GENERAL ELECTRIC

SUBJECT: IN THE MATTER OF 238 NUCLEAR ISLAND
GENERAL ELECTRIC STANDARD SAFETY ANALYSIS REPORT (GESSAR II)
DOCKET NO. STN 50-447

REVISED DRAFT RESPONSES AND MATERIALS UPDATE

Draft Responses to
Structural and Geotechnical
Branch Questions

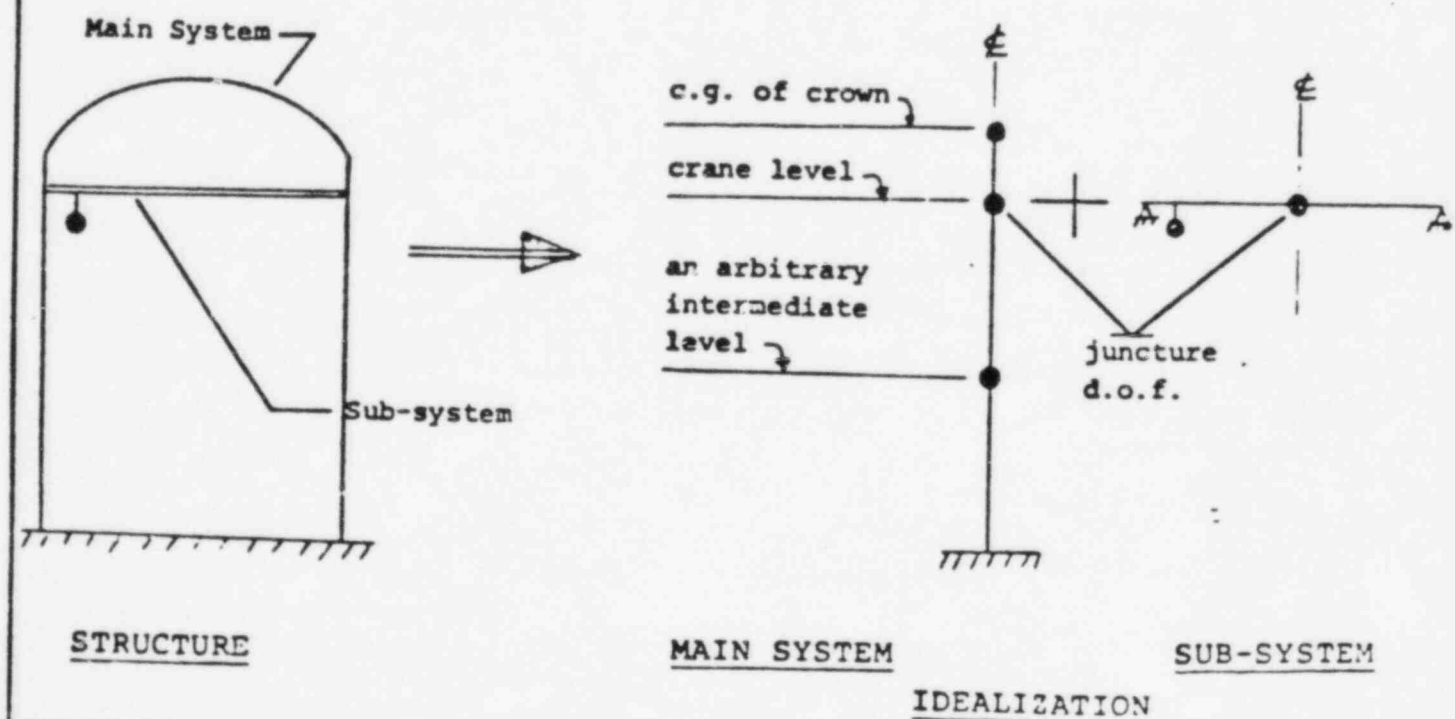
In Section 3.7.2.1.5.1.1 of your FSAR, you state that a study has been conducted which shows that the interaction between the steel containment vessel and the polar crane can be ignored and that the crane mass can be lumped into the containment model at that level. Provide this study.

The report on the study of polar crane interaction with the steel containment is ~~attached~~ provided below.

A. STRENGTH OF AUXILIARY BUILDING EXTERIOR WALLS

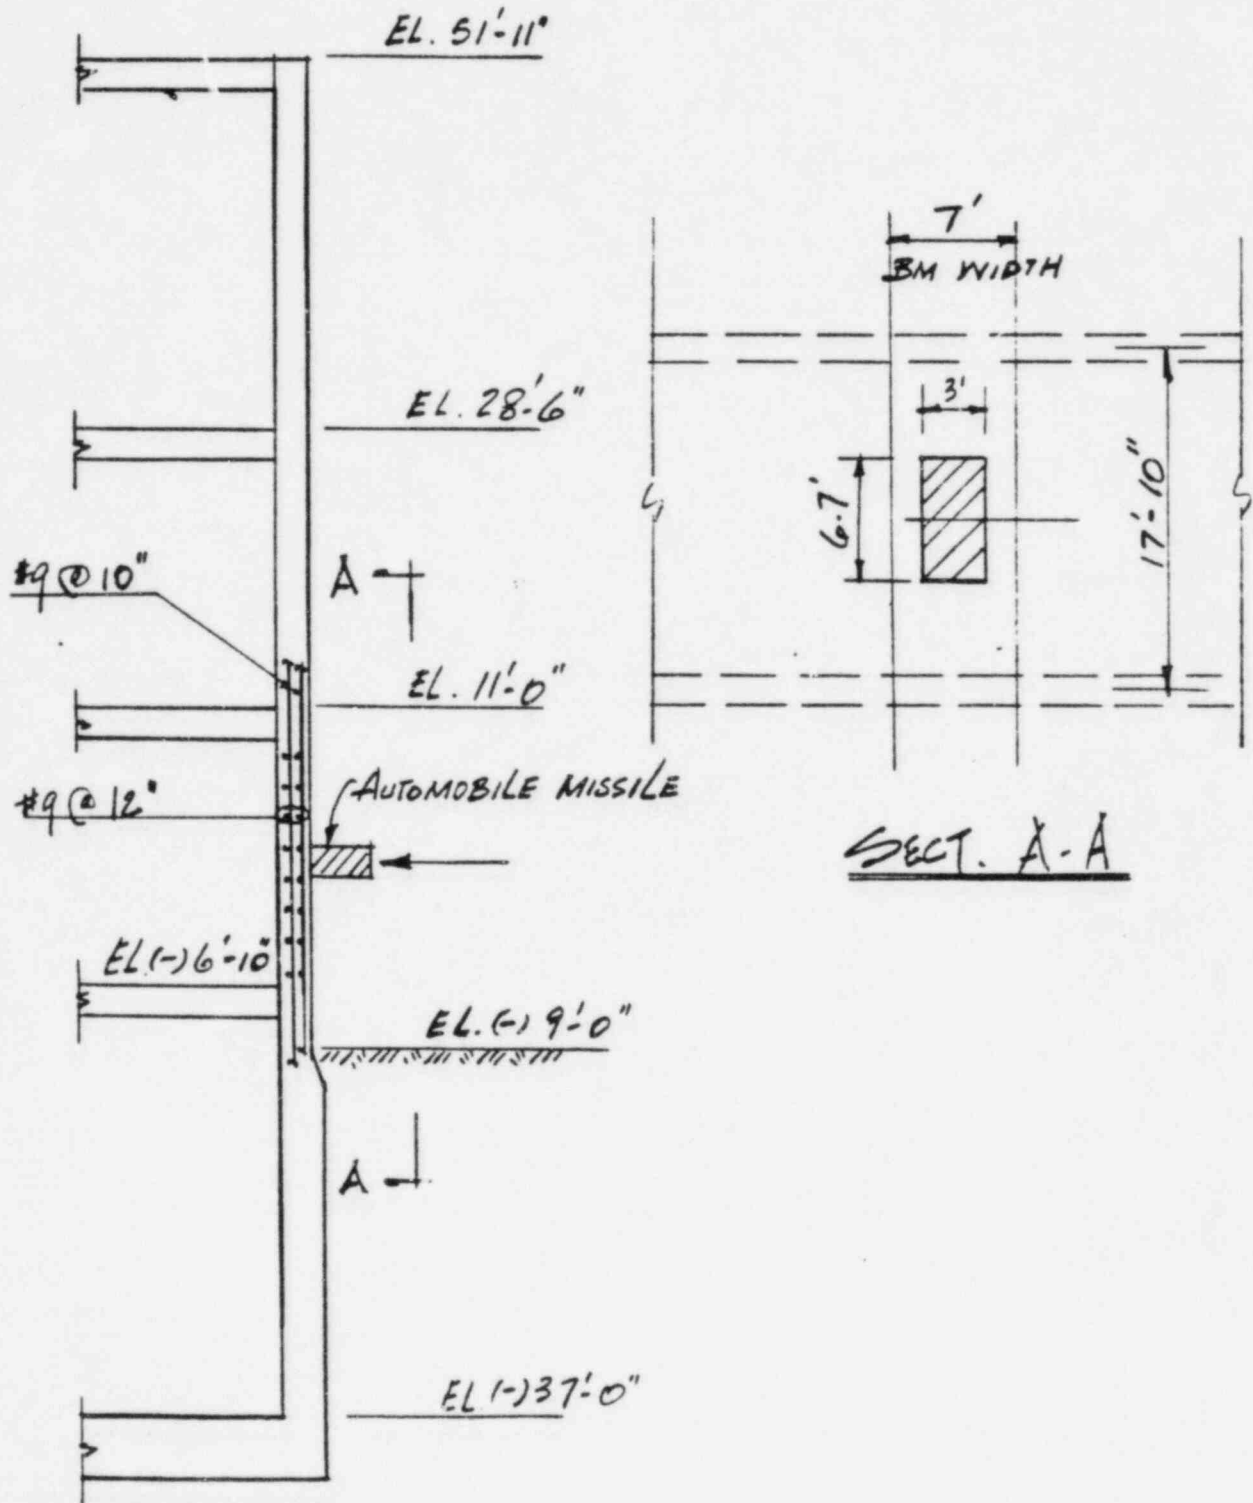
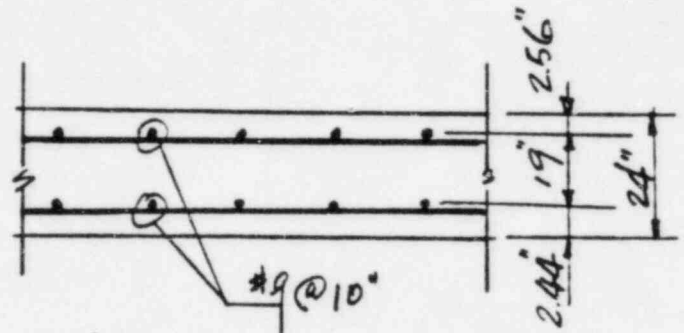
Provide information about the impact analysis for Automobile impact on Structures. (Ref. Section 3.5.3 earlier design procedures)

The method utilizes the energy balance technique which involves using the strain energy of the target at maximum structural response to balance the residual kinetic energy of the target resulting from missile impact. A plastic collision is considered, meaning the missile remains in contact with the target. In the case of automobile impact experimental data are available to enable definition of a force-time function. The equation of motion is then solved for the maximum displacement. The Bechtel topical report, BC-TOP-9A, on design of structures for missile impact was extensively used in this work.

CONSIDER THE WALL AS A ONEWAY SLAB SPANNED BETWEEN THE FLOOR SLABS

Figure 8.3-25. RPS Separation Scheme

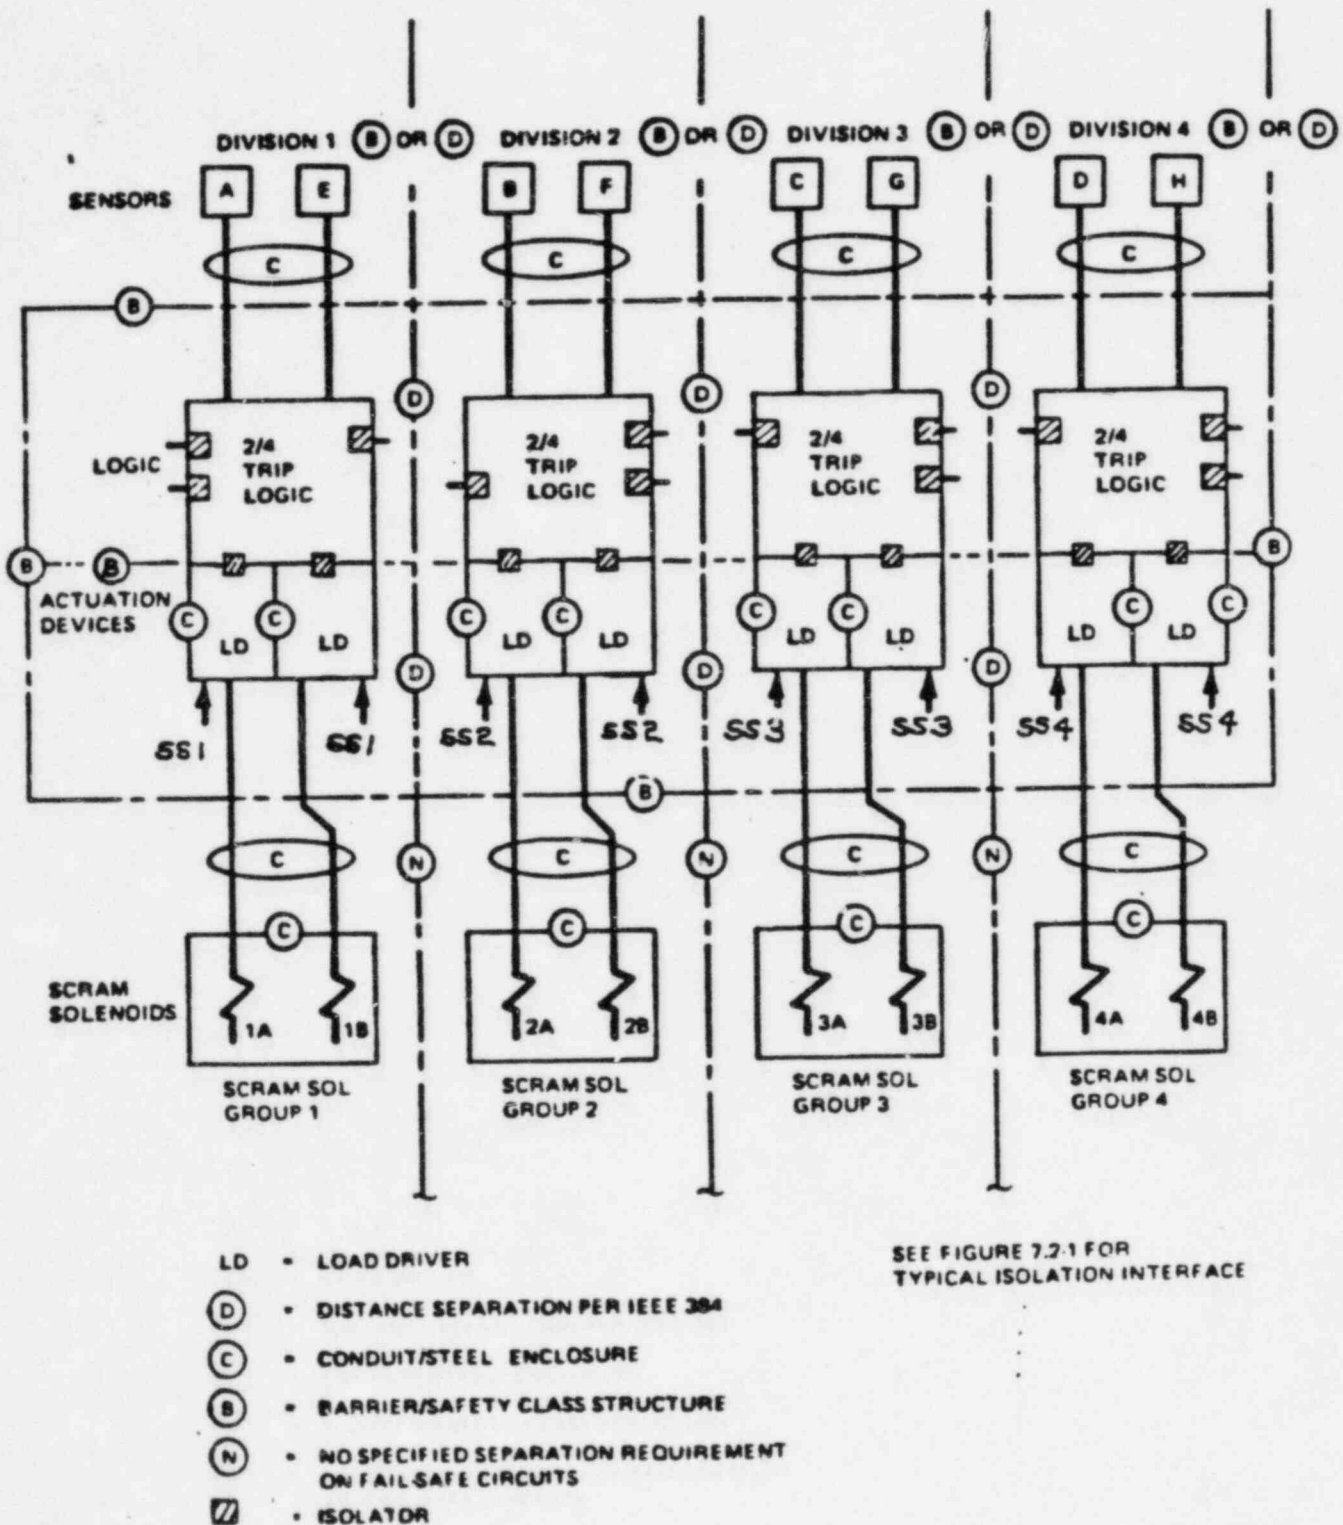
The separation you describe in Sections 8.3.1.4.2.3.1 and 8.3.1.4.2.3.2 of your FSAR for the scram solenoid circuits and the main steam line (MSL) isolation valve circuits must be justified by analysis, based on tests, to show that there is no detrimental effect on Class 1E circuits with which these circuits are run. Additionally, demonstrate that the function of the scram solenoid circuits and MSL isolation circuits will not be impaired by this arrangement. Explain how isolation is maintained between the Class 1E power supply feeding the "A" solenoids and the non-Class 1E power supply feeding the "B" solenoids since these circuits are run in a common conduit.

5?
Explain the use of the D1 through D4 inputs shown in Figure 8.3-24 of your FSAR, coming via isolators into the load drivers of the "B" scram solenoid circuits.

Solenoid "B" is fed from non-1E bus "B" power supply similar to bus "A". It is acceptable to run "A" and "B" solenoid power circuits together since the isolation is provided in the logic cabinets. Separate ~~non-~~ class non-1E power supplies are provided to enhance plant availability.

Figure 8.3-25 will be corrected on the basis of the above discussion. See attached marked copy.
